**NEBRASKA ARMY NATIONAL GUARD  
EAST CAMPUS READY BLDG SUSTAINMENT / ALTERATION**

PROJECT NO. 31020023

**ADDENDUM NO. 1**

ADD 1-20 Refer to Sheet E2.2–

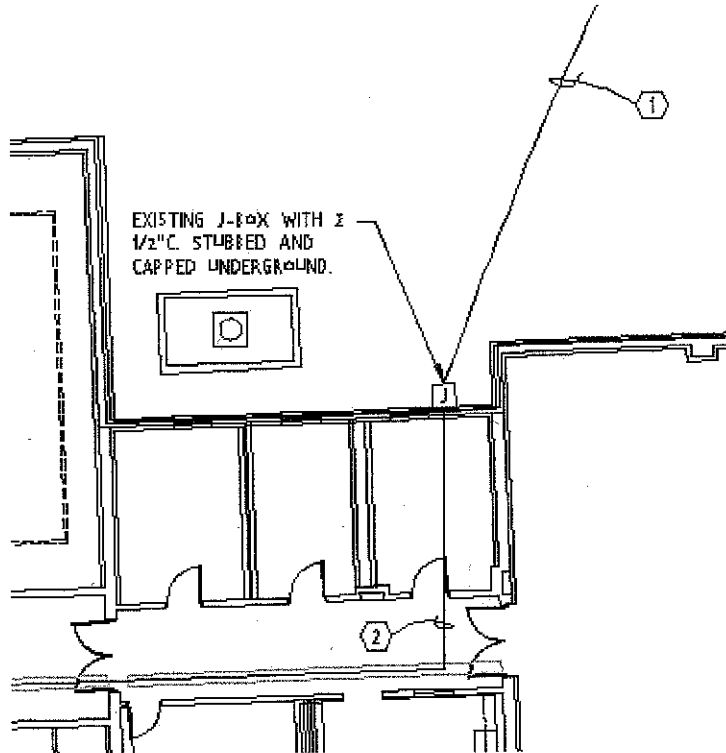
There is an existing J-box on the north exterior with 2 ½" c. stubbed out and capped underground at the Pershing Building. See detail below.
